Commonwealth Edison
1400 Opus Place
Downers Grove, Illinois 60515

February 15, 1991

Subject: Dresden Nuclear Power Station Units 2 and 3
Quad Cities Nuclear Power Station Units 1 and 2
Response to Station Blackout Safety Evaluations
NRC Docket Nos. 50-237/249 and 50-254/265

FIGURE 1

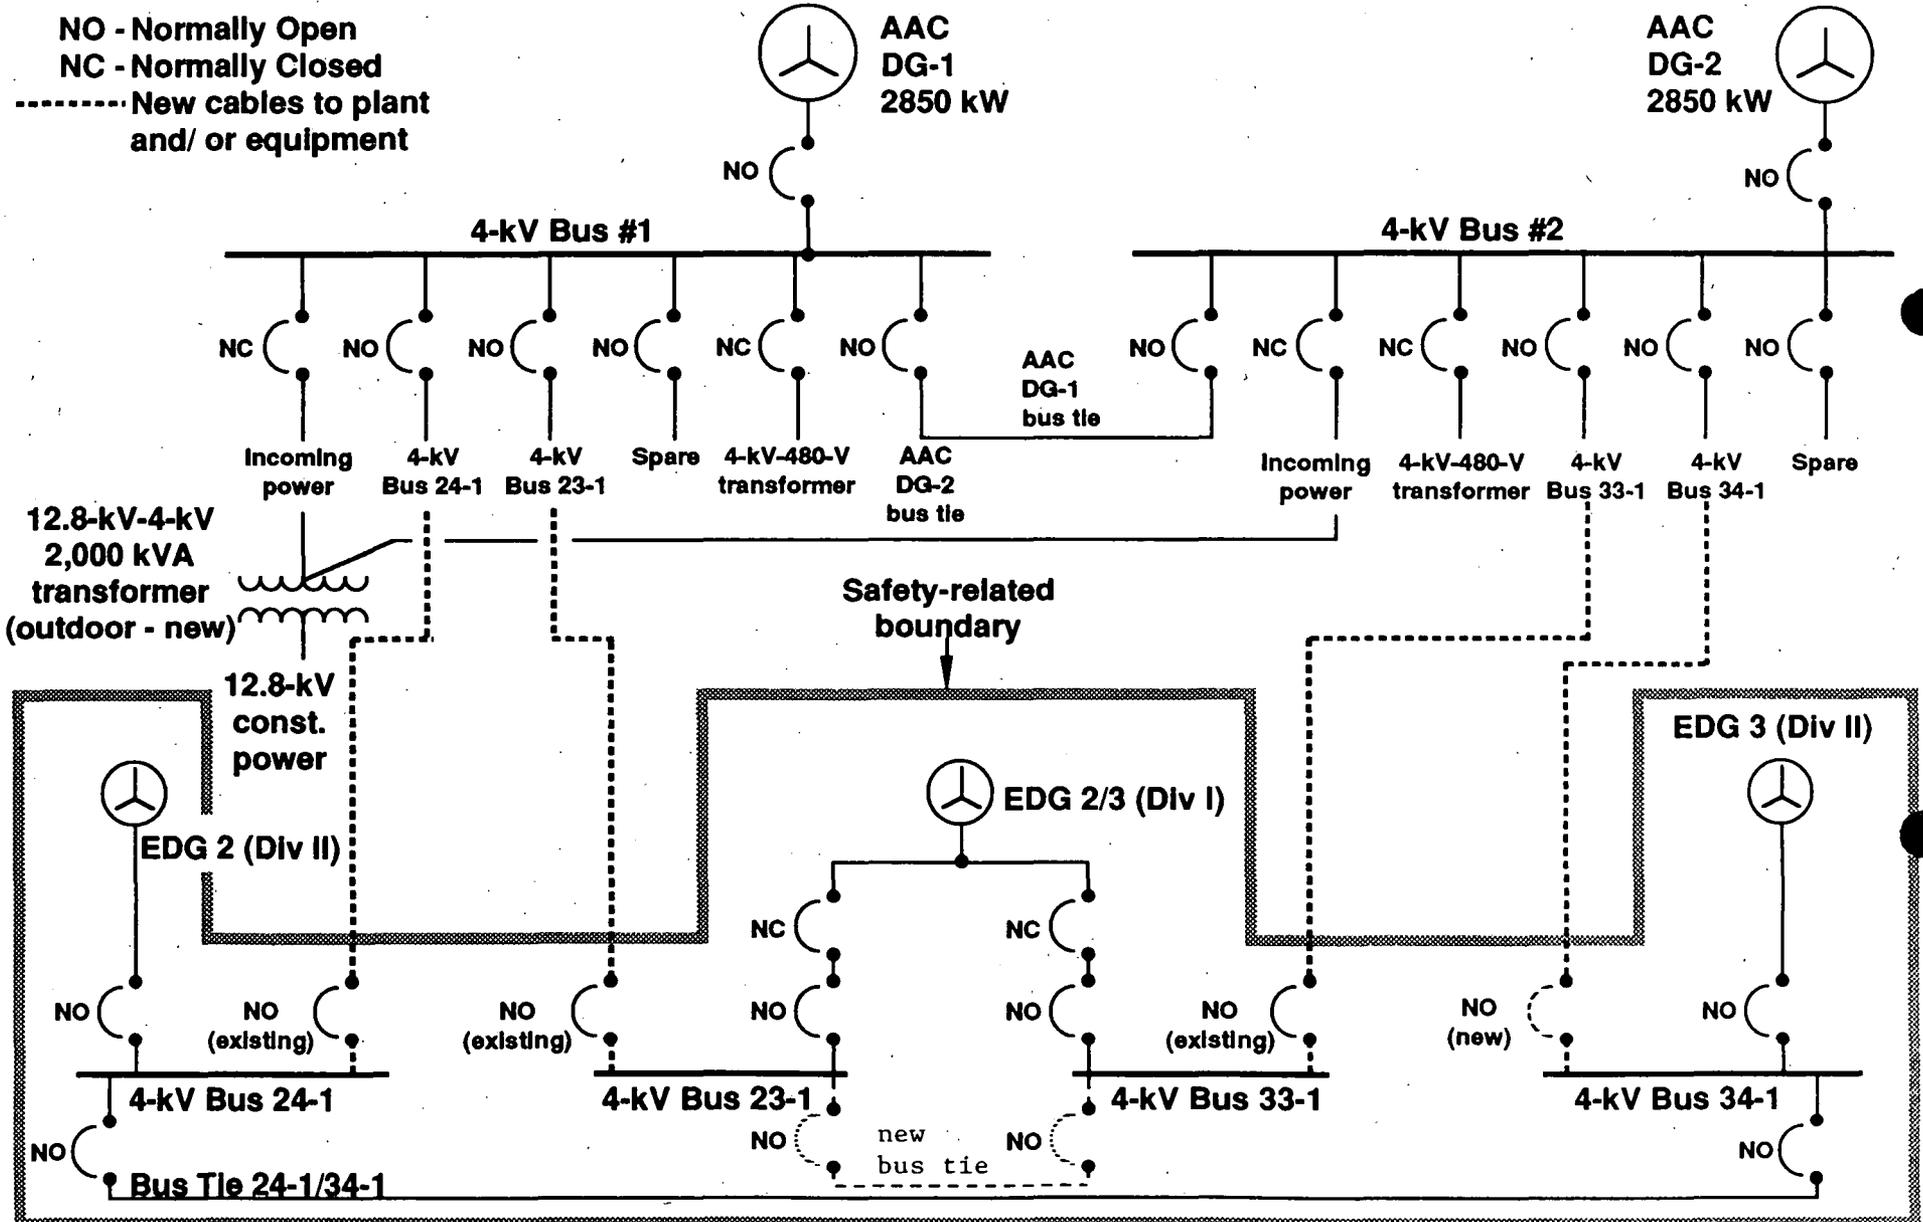
Preliminary engineering for the AAC power source indicates that it would be more advantageous to supply the generating capacity from two equally-sized diesel generators (instead of one), as shown on Figures 1 (Dresden) and 2 (Quad Cities). The AAC diesel generators will be installed in accordance with the criteria in Appendix B of NUMARC 87-00, and will have the capability to connect to all 4 kV safety buses (buses 23-1, 24-1, 33-1 and 34-1 at Dresden/buses 13-1, 14-1, 23-1 and 24-1 at Quad Cities). By maintaining the AAC power source capacity, and the ability to connect to all four safety buses, the 0.95 target reliability for the emergency diesel generators should remain unchanged.

CECo believes utilizing two diesel generators for the AAC power source will provide an enhanced design which will preclude the total loss of the AAC power source should one of the diesel generators become unavailable. Additionally, there is a concern that a single AAC diesel generator will have the capacity of providing fault currents which may exceed the interrupting capability of the existing 4 kV safety buses.

As part of the AAC power source modification, cross-tie capability between safety buses 23-1 and 33-1 at Dresden Station, and between safety buses 13-1 and 23-1 at Quad Cities Station, was being provided (utilizing the AAC power source bus) to improve the "Independence of Off-Site Power" classification to "Group I 1/2". Sections 2.1 and 2.2.2 of the safety evaluations indicate that in order to credit this cross-connect as a safe shutdown bus transfer, the connections from the output breaker of the proposed AAC power source to the safety buses would have to be safety grade. Since submittal of Reference (c), CECO has determined that a safety grade cross-tie will be installed directly between the safety buses (as shown on Figures 1 and 2), instead of connecting through the AAC power source bus. This configuration will ensure that the cross-tie will be credited as a safe shutdown bus transfer.

It should also be noted that the AAC power source (diesel generators), and its associated buses, breakers and cabling, will not be installed safety-related (as shown on Figures 1 and 2); however, the isolation breaker at each safety bus will be safety grade.
